Piper Aircraft Corporation  
Vero Beach, Florida, U.S.A.

# SERVICE *No.* 923 BULLETIN

Date August 16, 1989 M

SUBJECT: Main Landing Gear Actuator Reinforcement Bracket Replacement

Sketch "A"

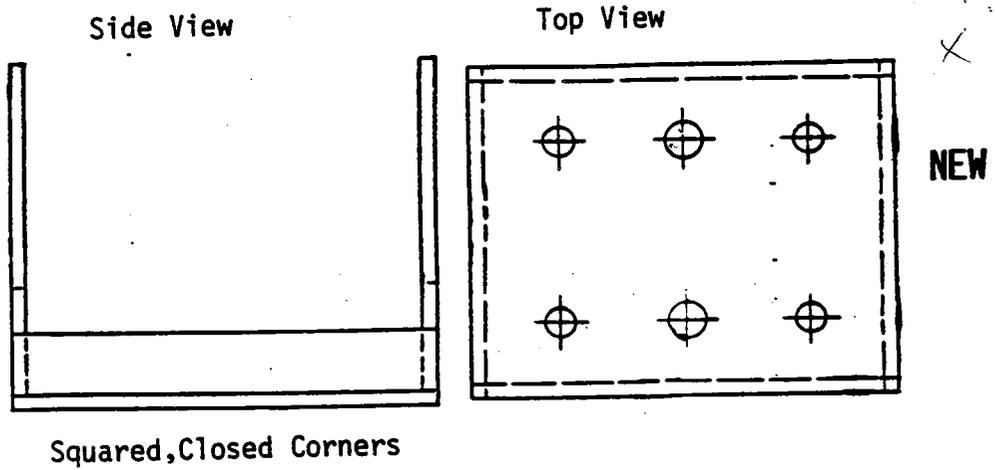
Some aircraft may have the new actuator reinforcement brackets (Piper Part Number 73786-02) installed as replacement parts. Refer to Sketch "A" for identification of Piper Part Numbers 40776-00 (old) and 73786-02 (new). Aircraft with Piper Part Number 73786-02 installed on both sides are in compliance with this Service Bulletin.

Sketch "B"

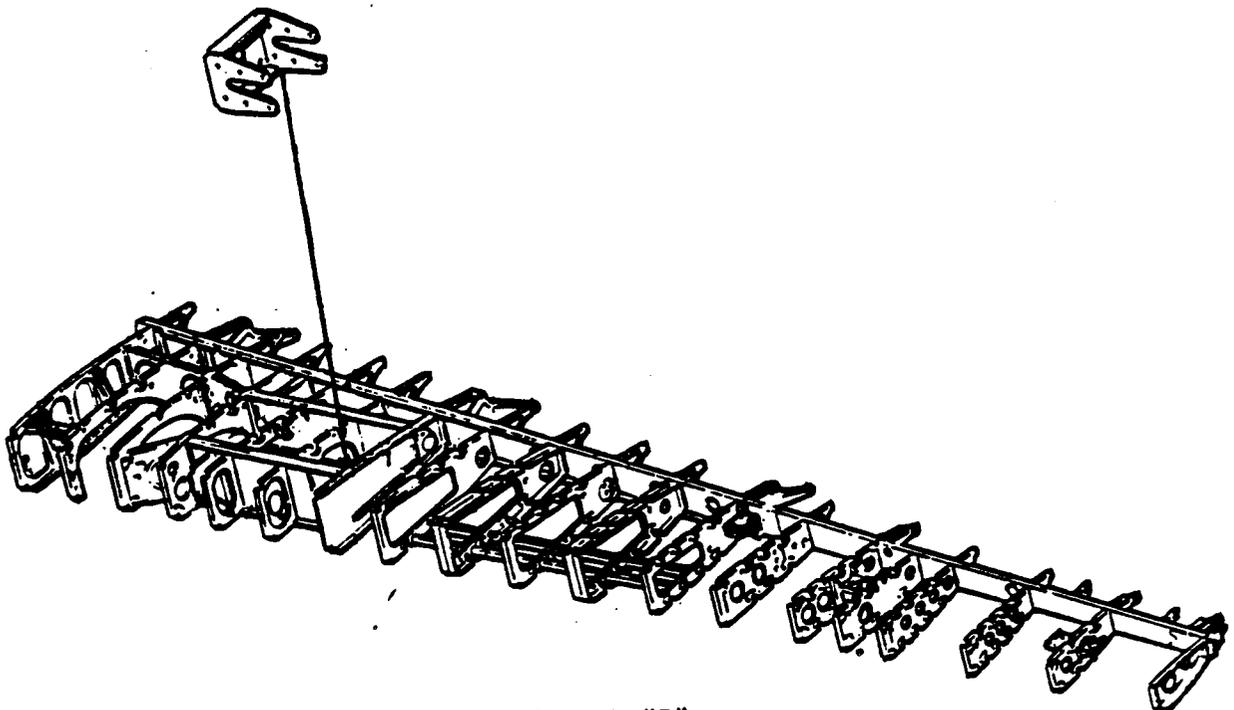
1. Place aircraft on jacks.
2. Locate the main landing gear actuator reinforcement bracket on the left and right wings. See Sketch "B" (attached).
3. Remove and discard original Actuator Reinforcement Brackets, Piper Part Number 40776-00. Install Piper Part Number 73786-02, as shown in Sketch "C".
4. Inspect and perform gear retraction per appropriate Chapter in the Maintenance Manual.
5. Remove aircraft from jacks.
6. Make appropriate logbook entry of compliance with this Service Bulletin.
